## FY 2024-25 Standard Plans Update Training

Rick Jenkins, P.E.
State Standard Plans Engineer
Central Office, Roadway Design Office
Rick.Jenkins@dot.state.fl.us

### 2024-25 Standard Plans Revision Log

### **Redline Sheet 5: Driven Post Hole**

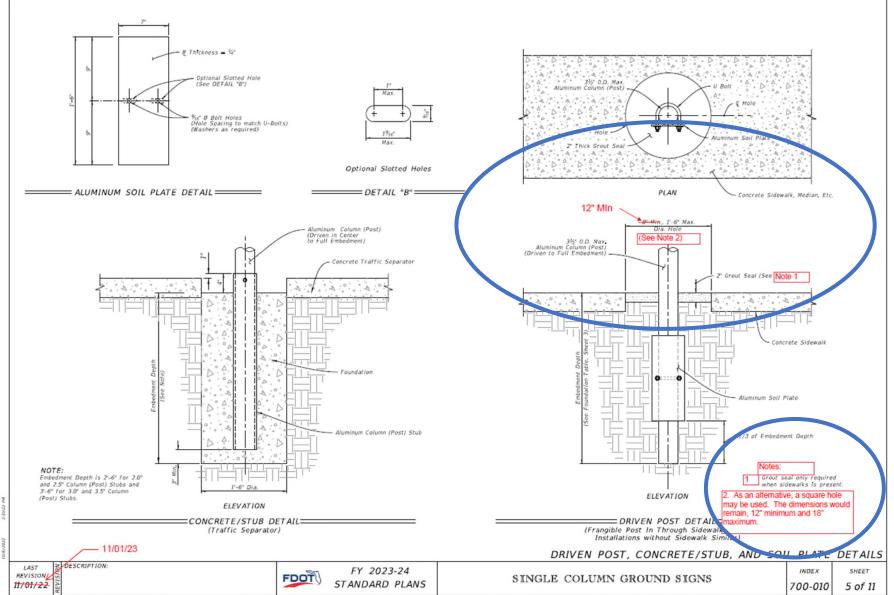
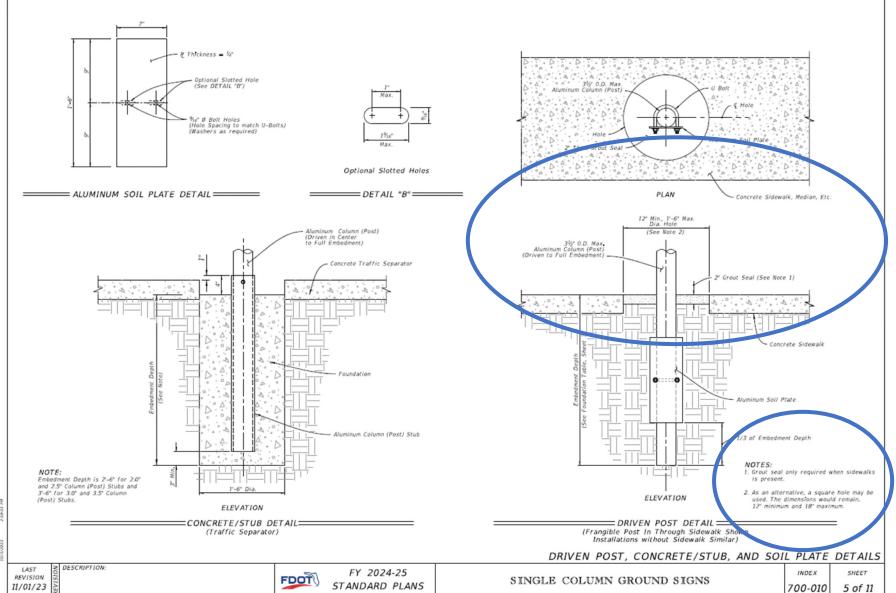
- Minimum Driven Post Hole Diameter now 12"
- Alternate Square Hole
   Option Added

- Updated Driven Post
- New Note 2

### **Sheet 12: NEW SHEET – Roadside Signing Assembly 9**

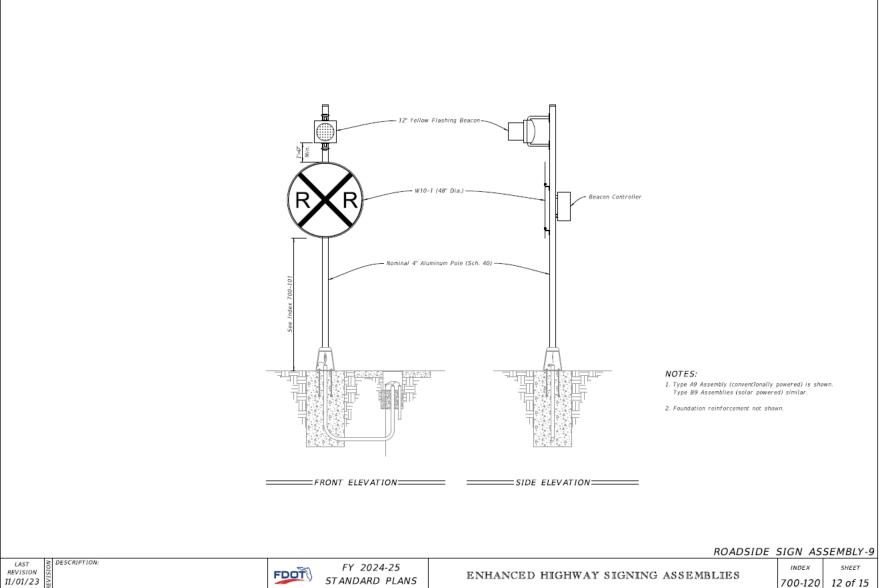
New Enhanced version of Railroad Warning Sign

### **Sheet 13: NEW SHEET – Roadside Signing Assembly 10**

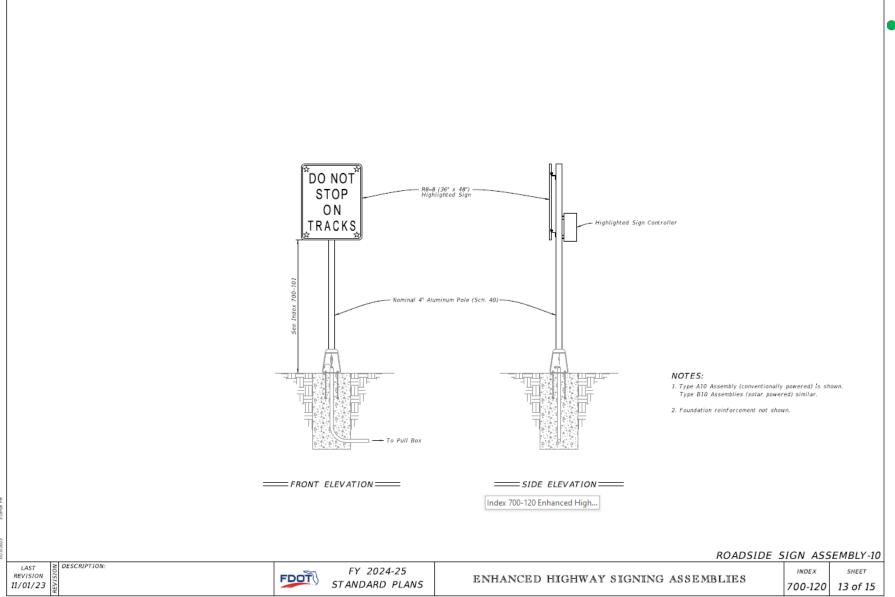
New Highlighted version of "Do Not Stop on Tracks" Sign

### **Sheet 14: NEW SHEET - Roadside Signing Assembly 11**

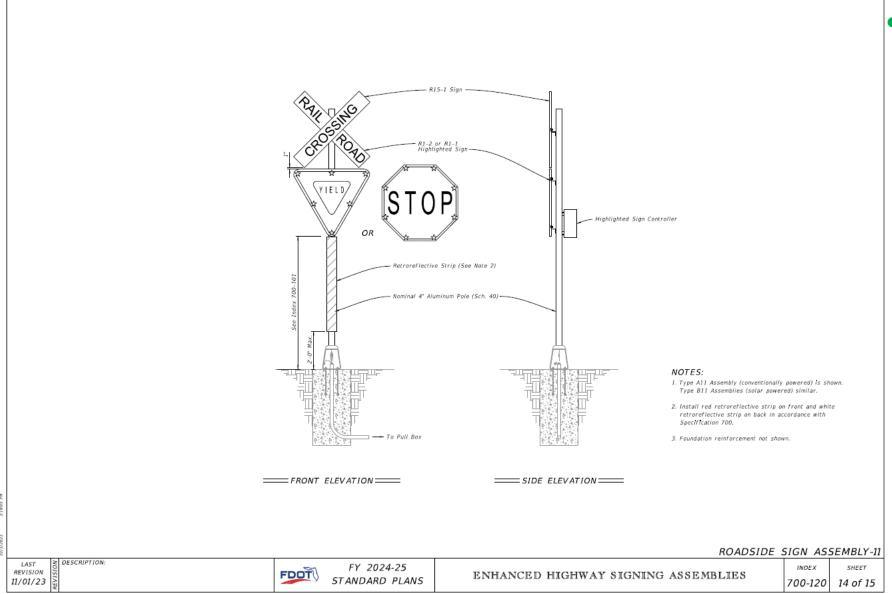
New Highlighted version of Yield and Stop Signs at Railroad Crossings

### **Redlined Sheet 1: Diagonal Pavement Markings**

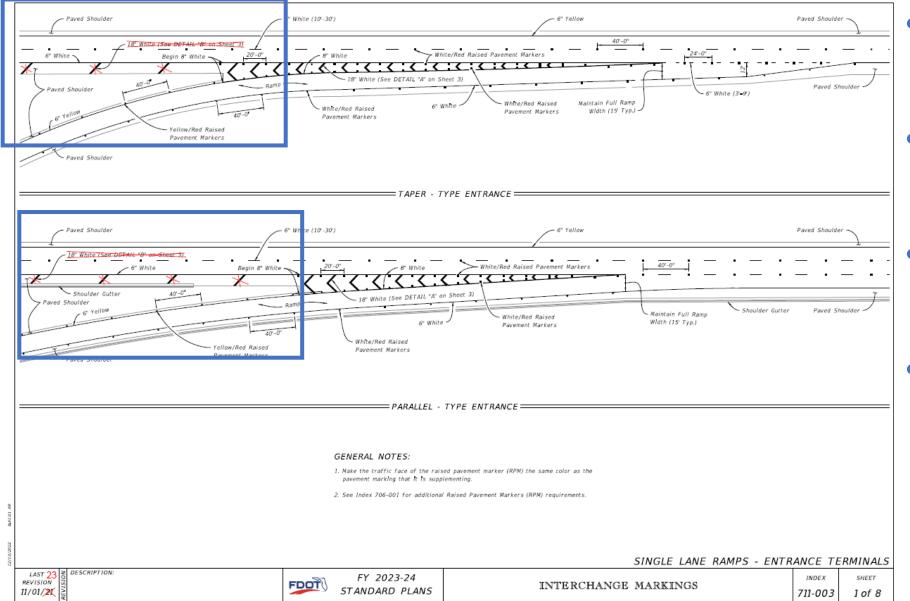
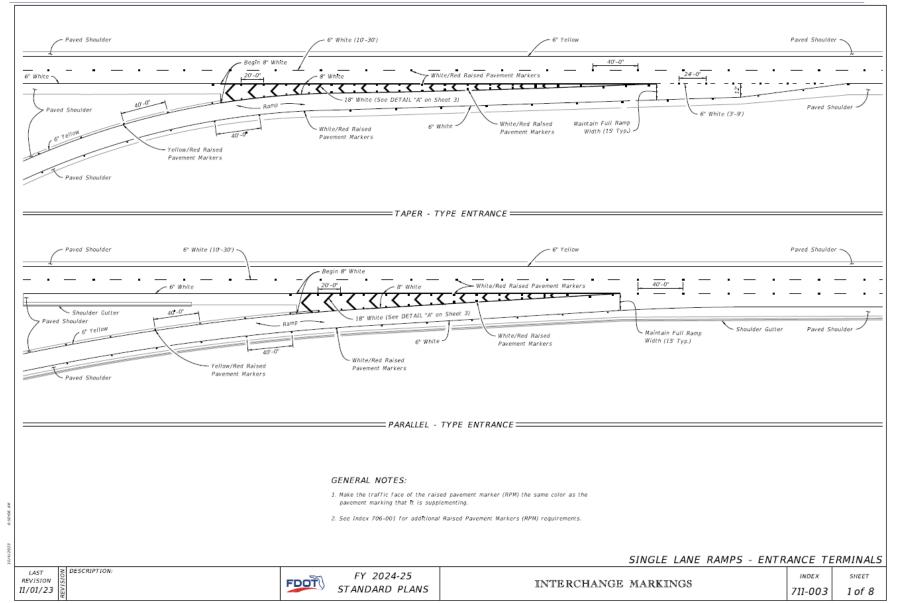
- Deleted Diagonal Pavement Marking
- Interchange EntrancesONLY
- Not Required per AASHTO Greenbook
- Same Update to Sheet 2

### **Sheet 3: Update Filter Fabric to Geotextile**

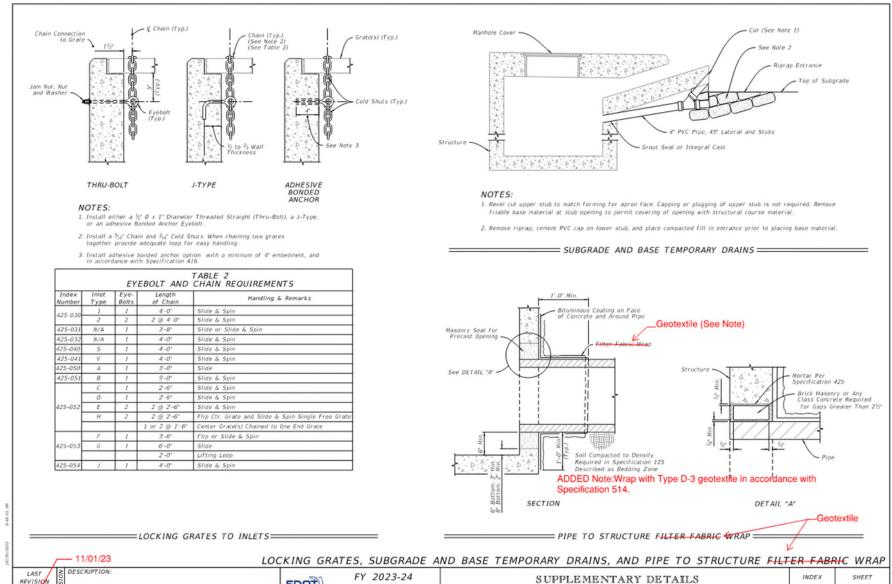
- Updated all references of Filter Fabric to Geotextile.
- Updates references pointing to Specification 985 to instead point to Specification 514.
- Add clarification in notes for types of Geotextile.

### **Sheet 1: Update Filter Fabric to Geotextile**

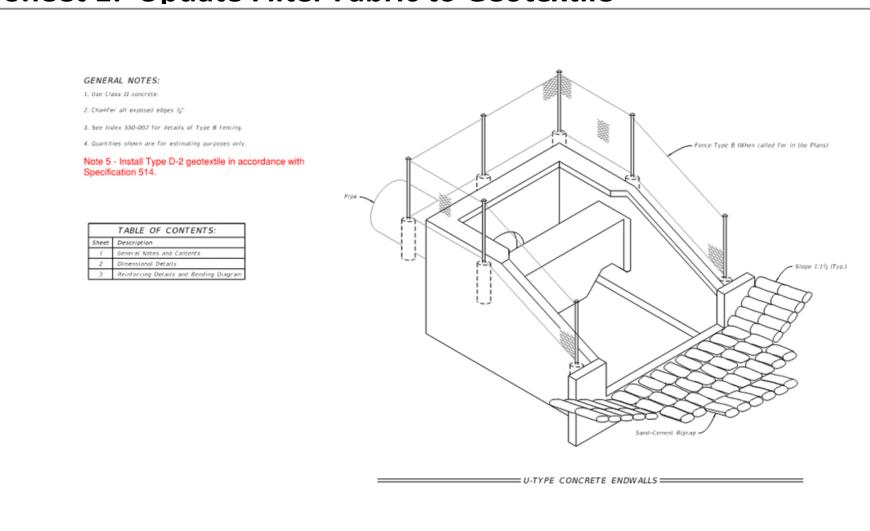
- Updated all references of Filter Fabric to Geotextile.
- Updates references pointing to Specification 985 to instead point to Specification 514.
- Add clarification in notes for types of Geotextile.

### **Redlined Sheet 1: Deleted Existing Controller Cabinet**

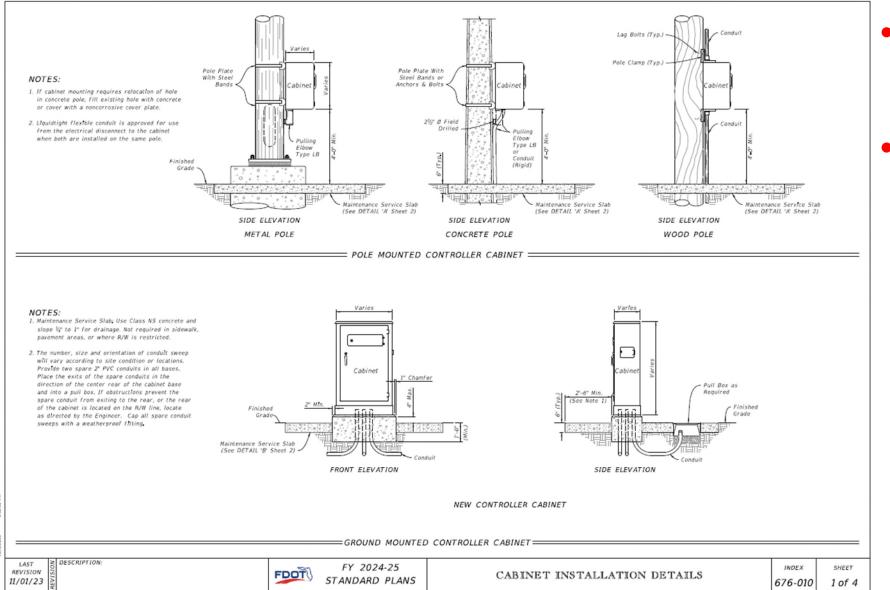
- Deleted Existing
   Controller Cabinet Detail
- TERL Requested Deletion

### **Redlined Sheet 2: Updated ITS Cabinet Detail**

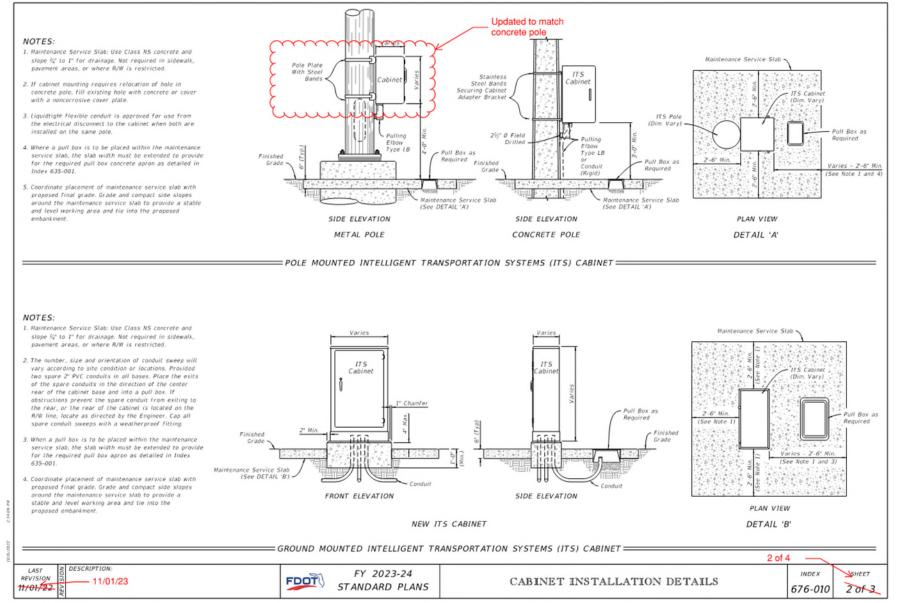
• Update Metal Pole Cabinet Brackets

### **Redline Sheet 1: Retroreflective Strip Case X**

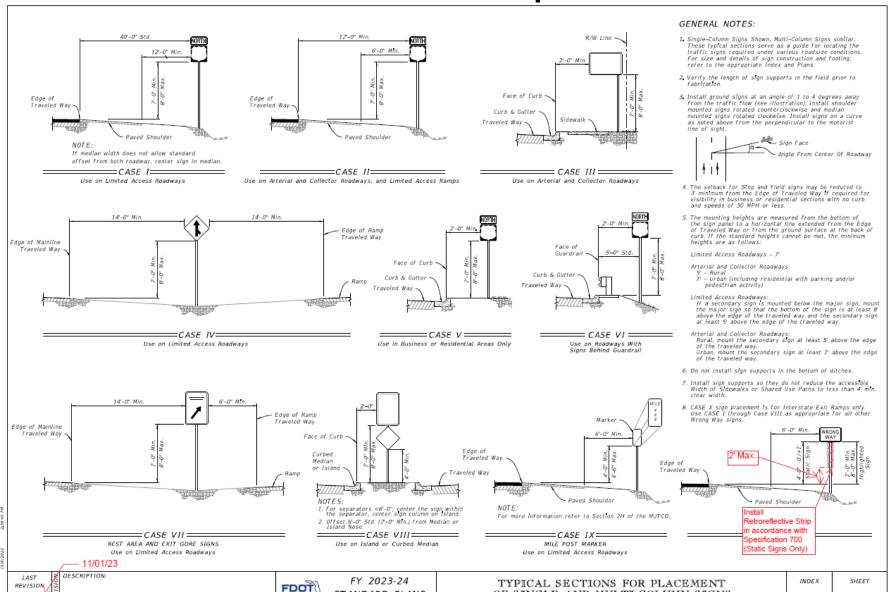
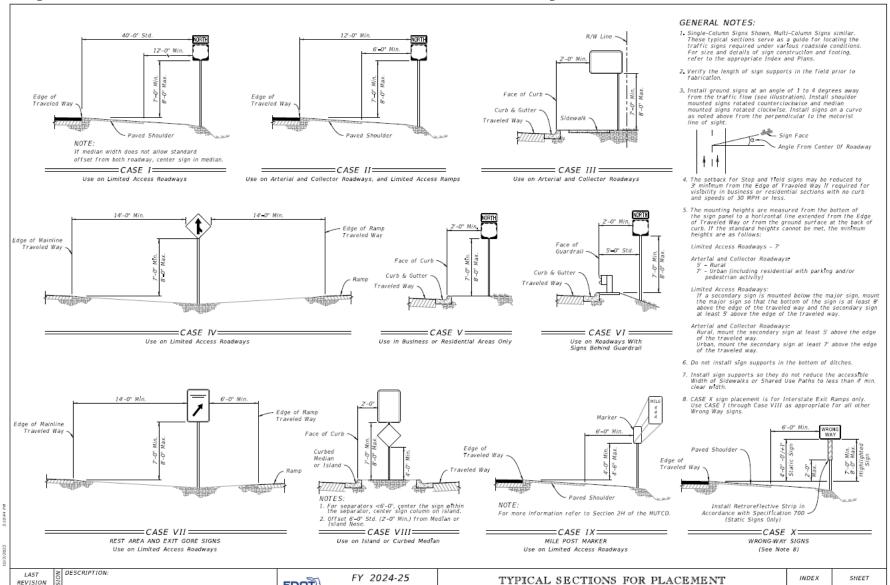
- Updated Case X
- Retroreflective Strip required per FDM 230.4
- Static WWD Sign ONLY
- Standard Specification
   700 updated

#### **Sheet 20: Layout to Rigid Barriers, <u>Trailing</u> Ends**

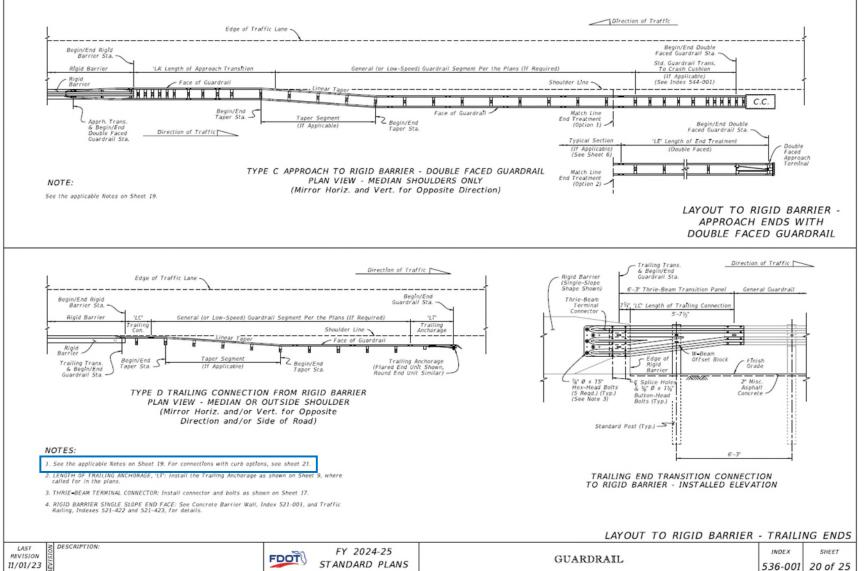
• Revised Note 1 Refers to Sheet 21 for:

**New** trailing curb connection options

### **New Sheet 21: Trailing End Bridge Connections – Curb Connection Options**

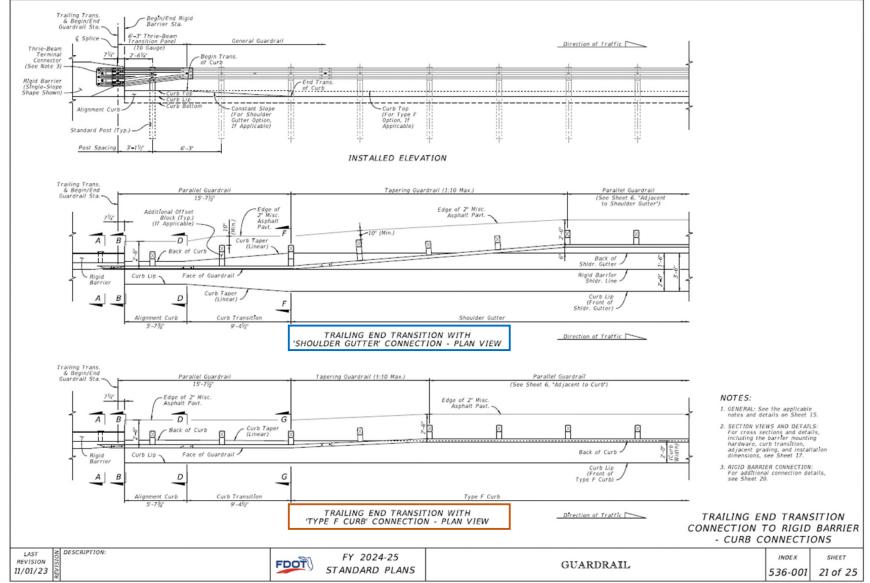
- New trailing end options for:
  - Shoulder Gutter Connection
  - Type F Curb Option
- NOTE: Similar to the Approach End, but shorter with less posts and panels (cost savings)

#### **Sheet 1: Detail B – Underground Feed – Service Poles**

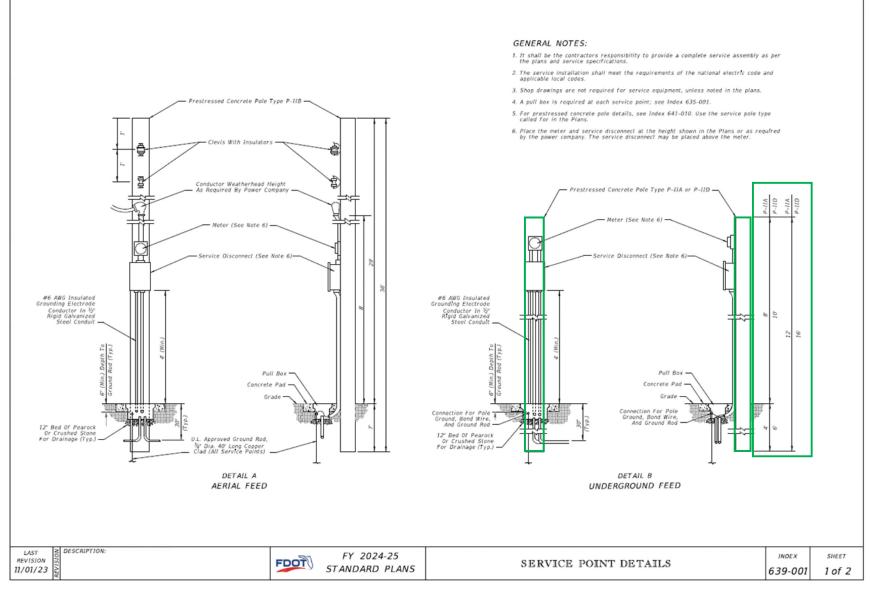
- New 16-foot service pole option
- Service Pole Type PIID
   (16-foot) was recently
   added to Index 641-010,

Sheet 5
- Options to Differentiate Poles:
  - *Type P-IIA − 12-foot*
  - Type P-IID 16-foot

#### **Sheet 1: Detail B – Underground Feed – Service Poles**

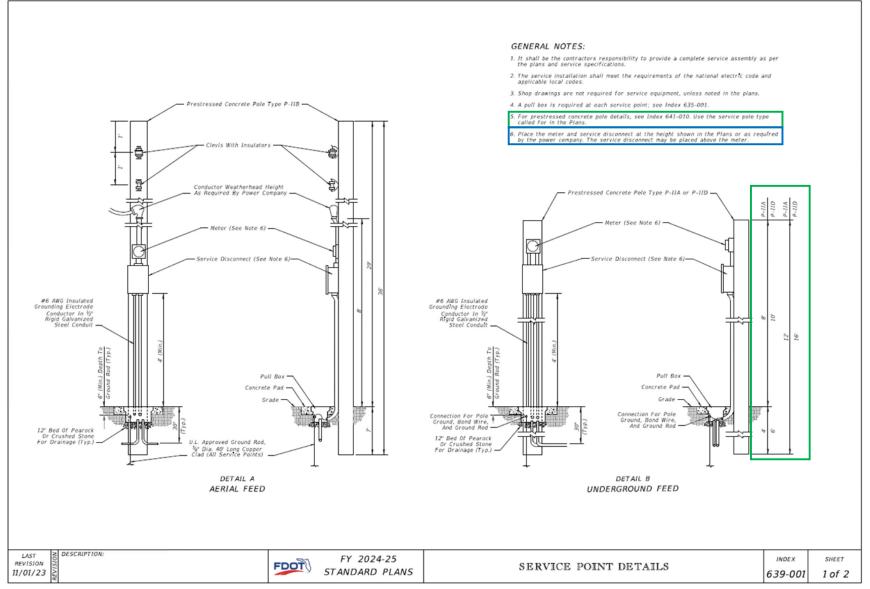
- Note 5, Pole Types: Added to reference Index 641-010
- Note 6, Device Heights: Added to explain that Meter and Service Pole disconnect height are defined by the EOR in the Plans or by the Power Company.
  - Meter can be placed below Service
     Disconnect if needed.

#### **Sheet 1: Details updated for Access Door Orientation**

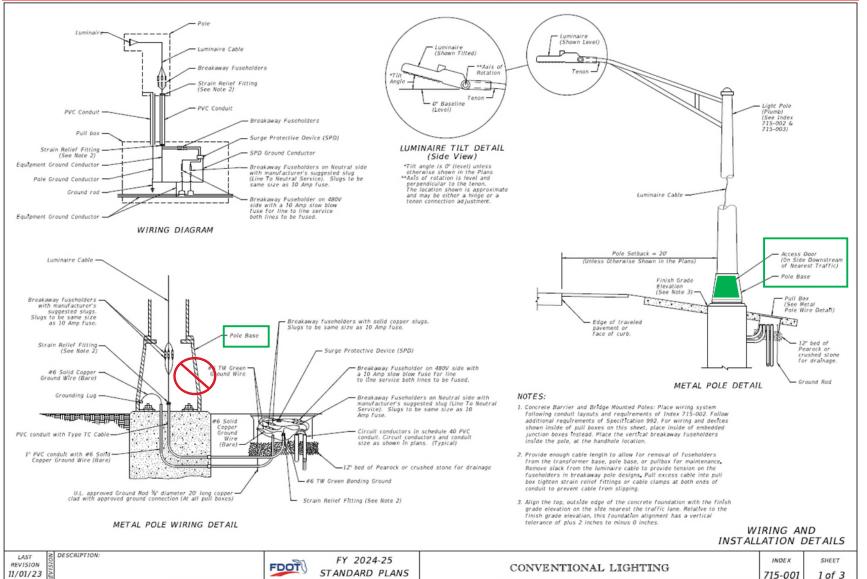
- Removed 'Access Door' from metal pole wiring detail (may misinterpret orientation)
- Added 'Access Door' detail to the Metal Pole Detail (orientation clearly established)
  - Place on downstream side of nearest traffic
  - Matches Standard
     Specifications 715-3

#### Sheet 1: All-New Developmental Standard Plans

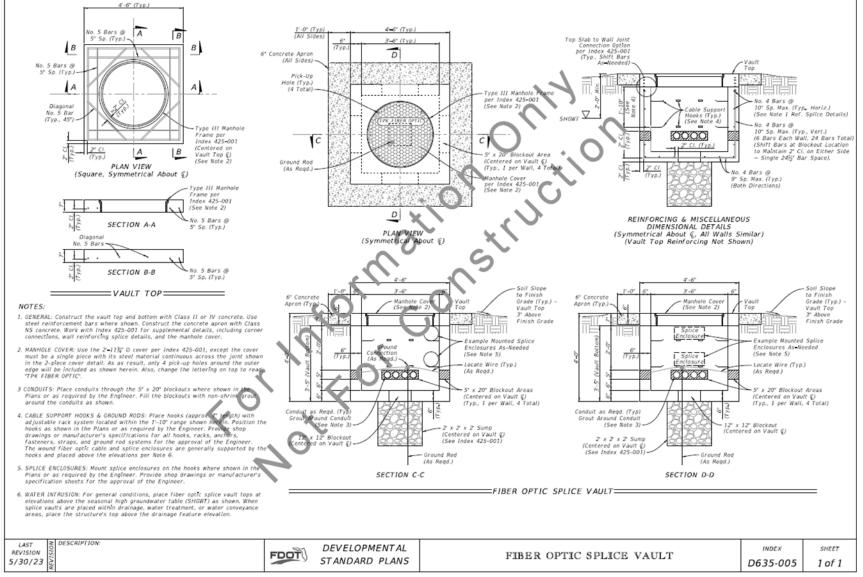
- Added at the request of the Florida Turnpike Enterprise
- "Vaults" are typically placed in medians to facilitate fiber optic access points and connections
- Standardization removes the need for project-specific structural design and shop drawings
- SDO designed for H-20 load
- Uses Type III Manhole frame per Index 425-001

- Plan is to publish with "regular" Standard Plans next year
- For this year...
  - Request approval for usage from CO Monitor per FDM 115.2.4
  - For supporting Specs, use with Blanket MSP for 635 & 996 (See Specs on the Web)
  - Pay Item is 635-4
  - I'll guide you!

# Sheet 1: Modified dim L for skew angle

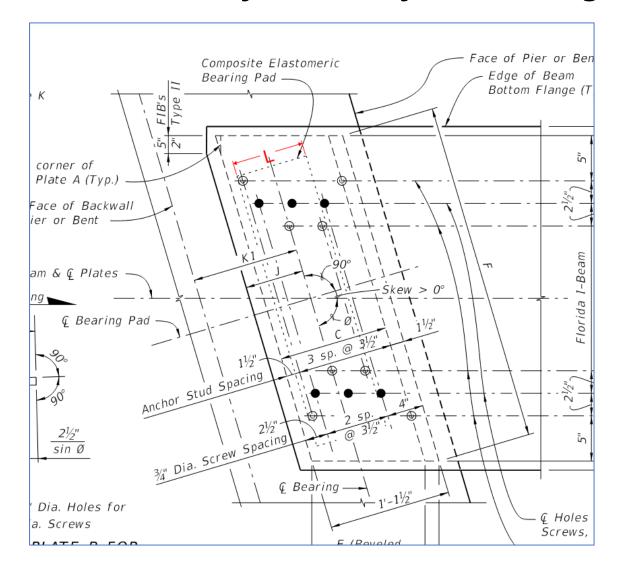
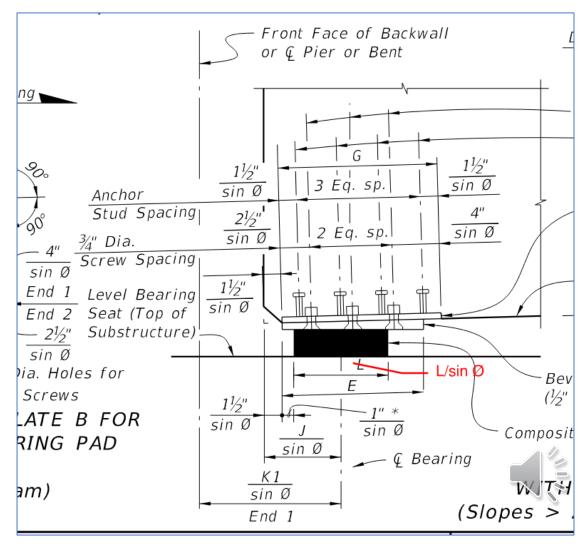
- Modified dim L for skew angle
- Added note to clarify negative dimension
